Re: Request for Technical Revision, Upper Gold Links Mine, Permit M-2016-083

Exhibit C – Mining Plan (Rule 6.3.3) REVISED May 3, 2017

**Exhibit E -- Mining Plan Map -- REVISED**

Upper Gold Links Mine  
REVISED  
Exhibit E - Reclamation Map

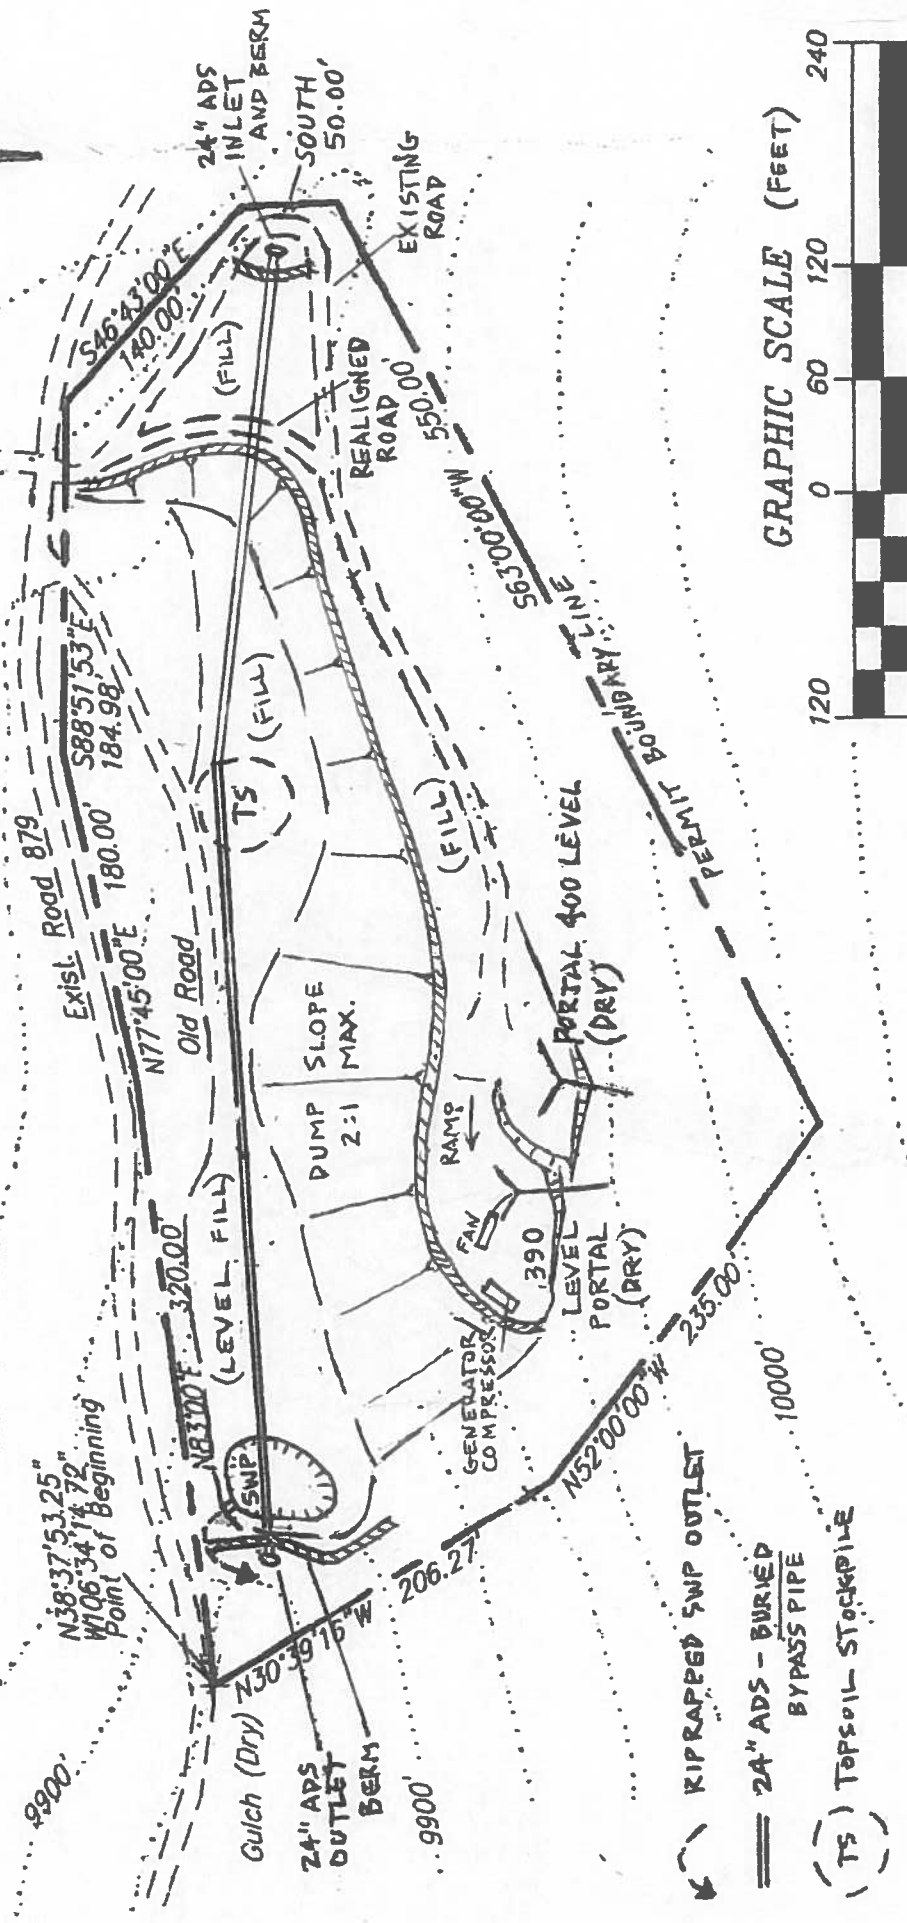
This TR is to facilitate improved ability to safely access the old existing workings and to facilitate the development of future areas of interest in the mine. The improvement and changes chiefly consist of relocating the original planned portal at the 300 foot level to a new site some 50 feet to the west of the old portal location on the 400 foot level. This new proposed portal would be developed at the 390 foot level and will be accessible via the same existing road leading to the existing upper portal, with a slight change in the access bench near the portals. This new portal, as with the old workings, will be a dry mine with no discharge occurring during the redevelopment program. The portal and access will not require significant change to the road or bench, and can be accomplished through limited earthwork. Please see the enclosed revised exhibits for detailed description.

The 400 Level portal will be maintained for ventilation and access, but no advancement through these workings is expected. Efforts will concentrate on surface earthwork to access the 390 Level portal site and developing the 390 Level workings. (see Exhibit E maps).

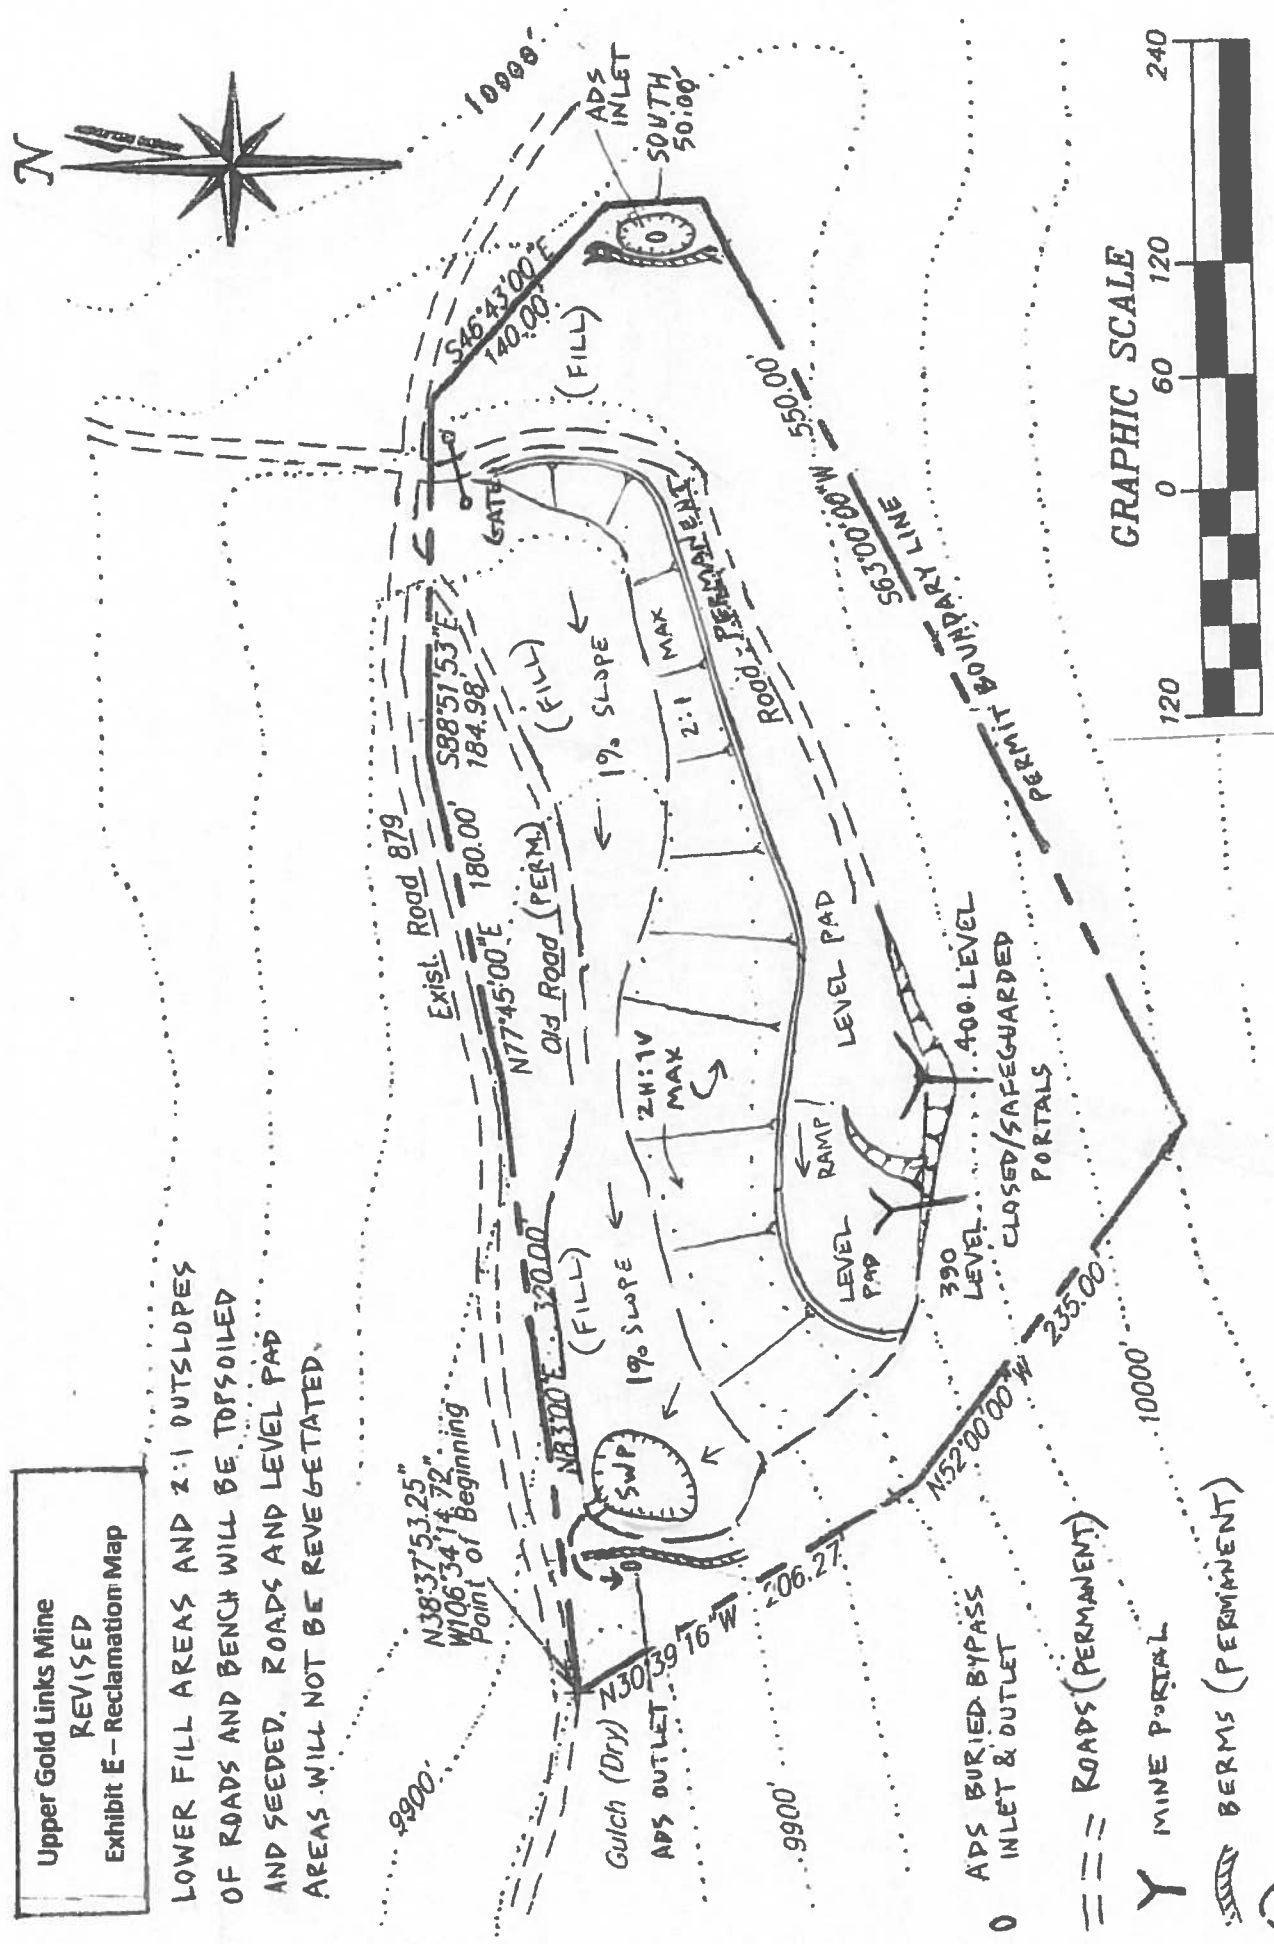
LOWER FILL AREAS AND 2:1 OUTSLOPES  
OF ROADS AND BENCH WILL BE TOPSOILED  
AND SEEDED. ROADS AND LEVEL PAD  
AREAS WILL NOT BE REVEGETATED.
